# United States Patent and Trademark Office

APPLICATION NO.	FILING DATE	FIRST NAMED INVENTOR	ATTORNEY DOCKET NO.	CONFIRMATION NO.
10/626,842	07/23/2003	Alan Phillips	PTG 02-76-2	9276
28268	7590 05/12/2006		EXAM	INER
	& DECKER CORPORA	ROSS, I	ROSS, DANA	
TOWSON, M	PPA ROAD, TW199 ID 21286		ART UNIT	PAPER NUMBER
•			3722	
			DATE MAILED: 05/12/2006	5

Replacement Sheet
Title: Router Bit System
Inventor(s) Alan Phillips et al
Serial No.: 10/626,842
Filing Date: July 23, 2003

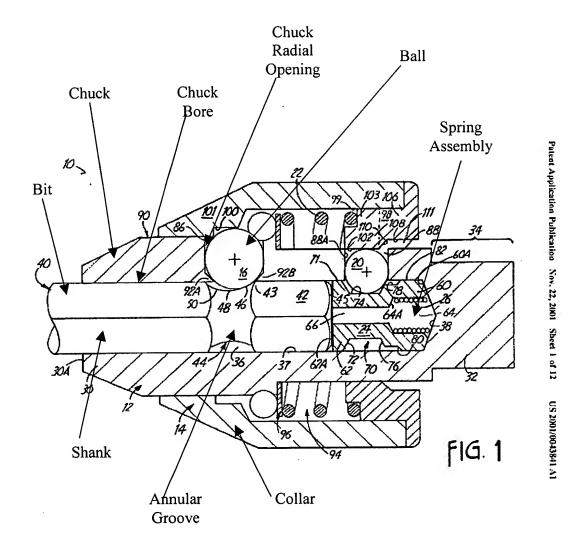
Regarding claims 1, 9 and 56, '841 teaches a rotary tool bit system including a cutter head and shank (see paragraph 0003); a router bit holding assembly including a chuck 12 having a bore (see figure 1 below) for receiving the shank (see figure 1 below), the chuck having an opening radially formed therein (see figure 1 below); a ball 16 received in the opening (see figure 1 below) for engaging the annular opening (see figure 1 below) of the shank (see figure 1 below) when the shank (see figure 1 below) is received in the bore (see figure 1 below); a collar 14 concentrically disposed about the chuck 12, the collar 14 sliding axially between a first position (see figure 1) and second position (see figure 2); wherein when the collar is moved to the first position (figure 1) the collar 14 is configured to hold the ball 16 in engagement with the annular groove (see figure 1 below) and when the collar is moved to the second position (see figure 2) the collar 14 is configured to allow the ball 16 to be disengaged from the annular groove (see figure 1 below).

Regarding claims 2 and 10 '841 teaches spring assembly for biasing the collar 14 to the first position (see figure 1 below and paragraph 0034, for example) and the compression spring being compressed as the collar 14 is moved to the second position.

Regarding claims 4, 5 and 12, as seen in figure 1 below, the tool bit has a tapered end and is the bore is configured to receive the shank.

FIG. 2

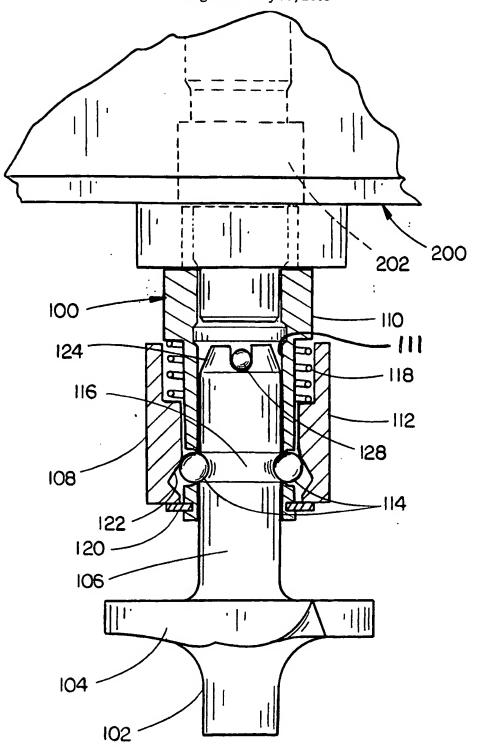
1. The replacement drawing sheet for Figure 2 was received on 13 February 2006. This drawing is acceptable.
